MX0023A-01A

# Modification Recommended Service Note

## InfiniiMax 25 GHz RC Probe Amp with AutoProbe 2 Interface

Figure 1.

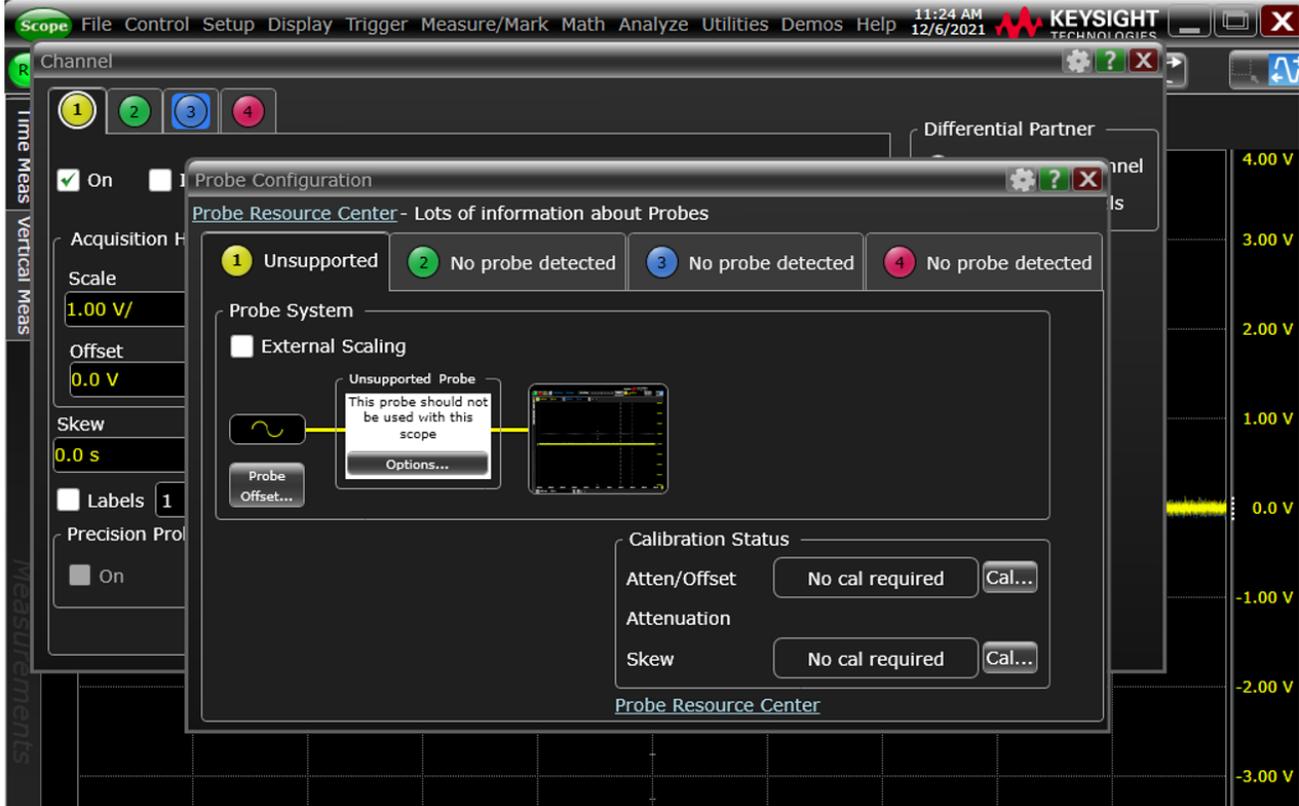
The early shipments of MX0023A probes have been found to 2 quality concerns that can cause probes to not be recognized when attached to the scope channel. Please see Figure 1.

1. AutoProbe Interface 2 Flex Circuit alignment
2. Capacitor failure

Please return defective probe amplifier to service center for repair.
